BUSCONNECTS –C3 Ballymun to City Centre

Accessibility Audit Report

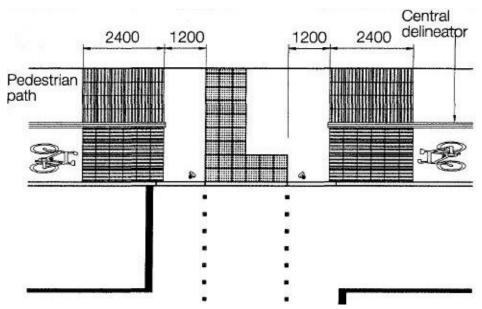
As main pedestrian crossing points shortcomings, it is remarkable the absence in of no dropped kerbs provided or dropped kerbs with inadequate width.

Some tactile paving used in crossing points during the route, need to be reviewed.

Uncontrolled crossing at side road junction. St. Mobhi Boithirin

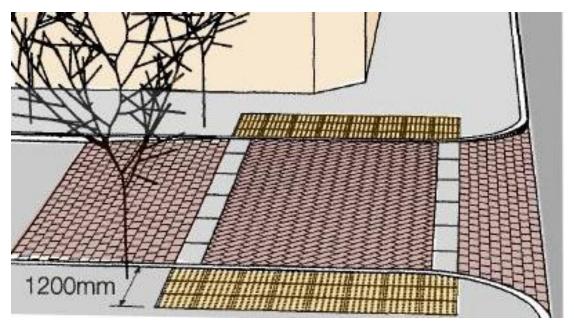
Shortcomings: Level difference edge kerb and carriageway greater than 6mm. Recommendations: Footpath and carriageway should be flushed correctly as in the figure below. Width of the central kerb should be extended as the width of travel.

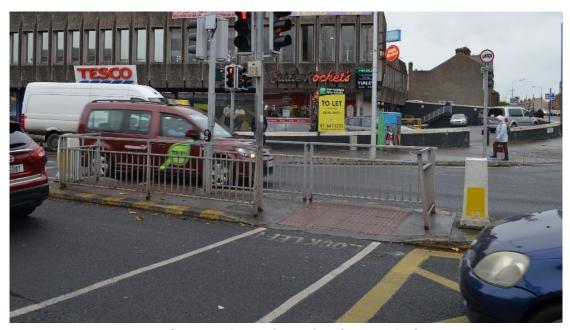
Recommendations: An adequate tactile paving should indicate with its surface the proximity of a crossing, at the end of the corduroy slabs.

Provide the adequate "Buff or grey" blister tactile paving. Depth of 1.2 m (in-line), gradient 1:12 max. Level difference of dished kerb: 6mm (max). The central kerb should be flush with the carriageway surface.

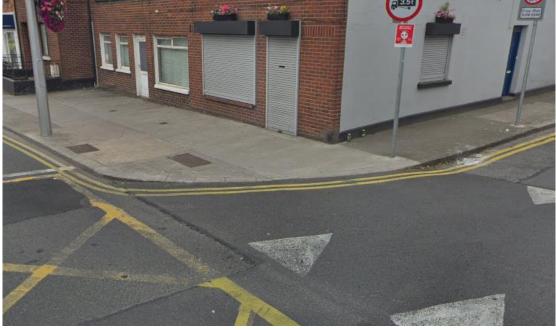
Shortcomings: Absence of tactile paving in a side road.

Recommendations: A tactile surface: "buff" or grey should be installed. The location of traffic signals should guarantee the minimum width of 1200mm. for people with mobility impairment.

Phibsborough Road and Devery's Lane

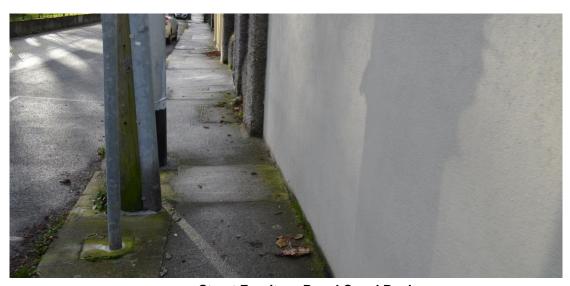
Shortcomings: Bollards linked with chains.

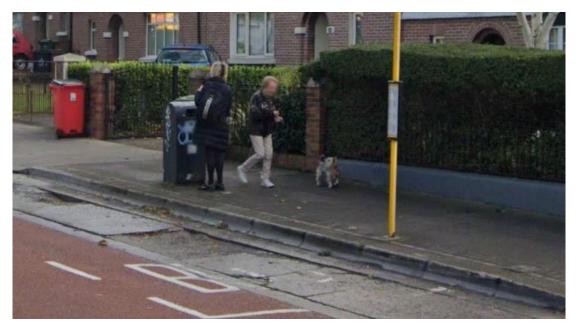
Shortcomings: Narrow footpath with street poles.

Recommendation: Where a level access route is provided: the minimum clear width (between walls, upstands or kerbs) should be 1500 mm. Street furniture, such as lighting columns, signposts, litter bins, seats, etc, should be located at or beyond the boundaries of the access route. (Technical Guidance Document M).

The width can reduce to 1200 mm. on short constricted sections of an access route.

Drainage in Constitution Hill

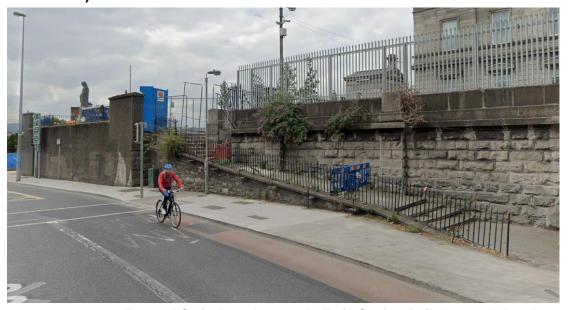
Shortcomings: The position of the drains can cause slopes on the footpath that can make difficult the mobility of disabled people.

Uncontrolled crossing-LUAS Church Street-Intersection with Chancery Street

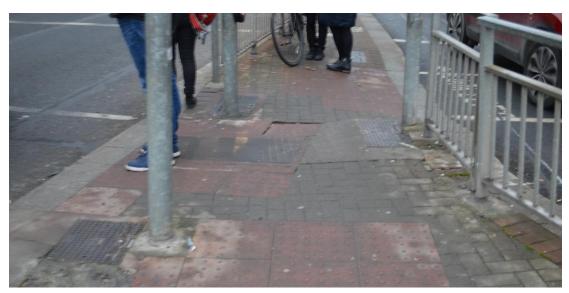
Shortcomings: Uncontrolled crossing point without the correct tactile paving Recommendations: "Buff or grey" tactile paving. Depth of 1.2 m, gradient 1:12 max. Level difference of dished kerb: 6mm (max). . For on street platform edges lozenge tactile flag paving should be incorporated for warning users where Tram schemes' platform edges begin.

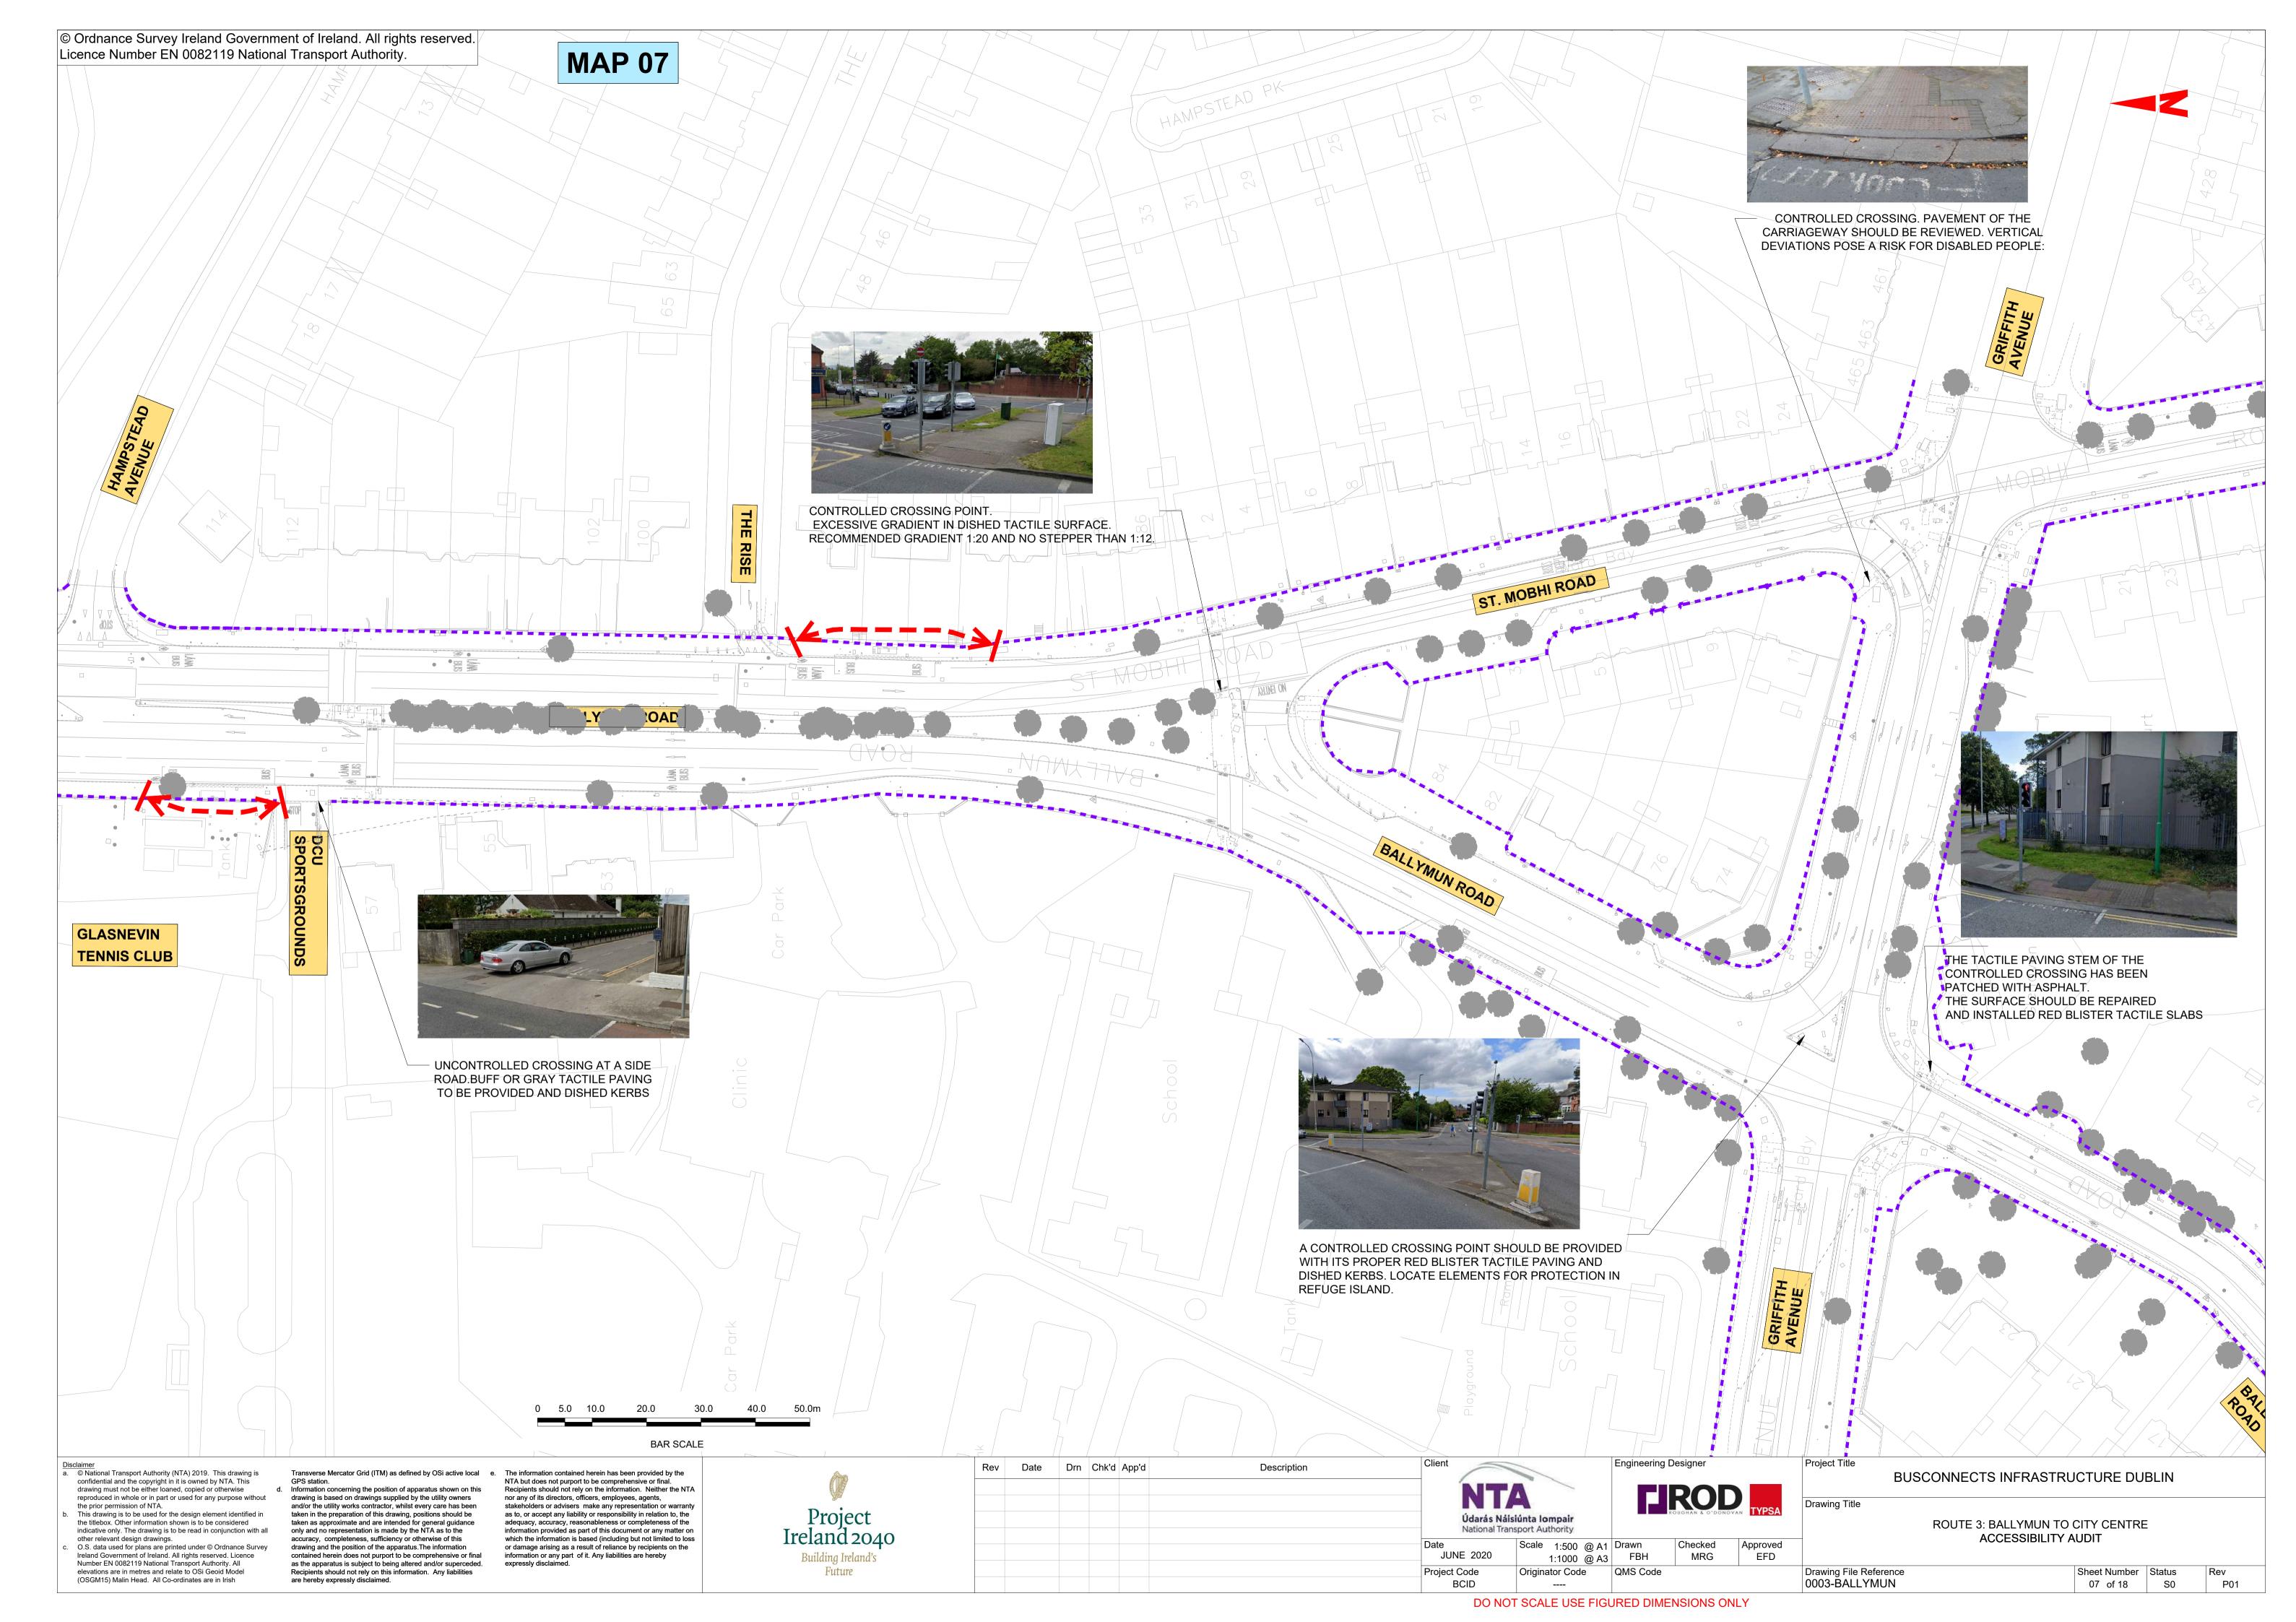
UNCONTROLLED CROSSING POINT. BUFF OR GREY" TACTILE P SHOULD BE CONSIDERED. DEPTH OF 1.2 M, GRADIENT 1:12 MAX. LEVEL DIFFERENCE OF DISHED KERB: 6MM.

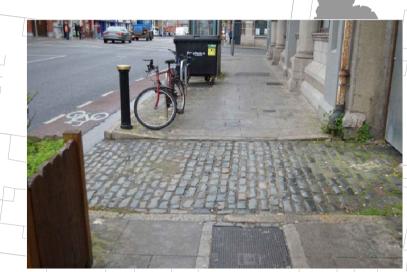
CHANGE IN LEVEL. NO ACCESSIBLE PASS. A NEW UNDERPASS FOR CYCLE ROUTE AND PEDESTRIANS IS PROPOSED. TACTILE WARNING SURFACE (400MM.MIN) AT THE START/END OF THE STAIR SHOULD BE CONSIDERED AND A CONTINUOUS HANDRAIL ON EACH SIDE OF FLIGHTS. AN ALTERNATIVE ROUTE

ON STREET-ACCESSIBLE CAR PARKING. DIMENSIONS AND SIGNALS MARKS TO BE REVIEWD. DIMENSIONS OF 3.6 x 7 m. AS PER TGD-M.
